SERVICE BULLETIN

TR-8400

#845

SUBJECT: TR-8400 RX INTERNAL SPURIOUS SIGNALS

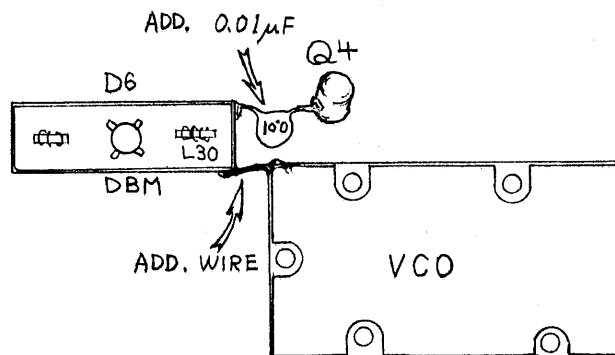
Receiver internal spurious signals occurring at xx1.7MHz and xx6.7MHz may be reduced or eliminated by adding an additional ground and bypass capacitor in the PLL. These are third overtone (21.6MHz) products of the PLL IF, (7.2MHz). This applies to all units before S/N 111xxxx.

1. Remove the top cover (4 screws).
2. Remove the rubber conductive shield.
3. Remove the aluminum cover from the PLL unit X50-1670-xx (17 screws).
4. As illustrated, solder a jumper between the DBM and VCO compartments.
5. Solder a .01 μ f 50V disc ceramic capacitor (CK45F1H103Z) from the DBM shield to the case of Q4 (3SK76 or 3SK92).
6. Reverse steps 3-1 to reassemble.
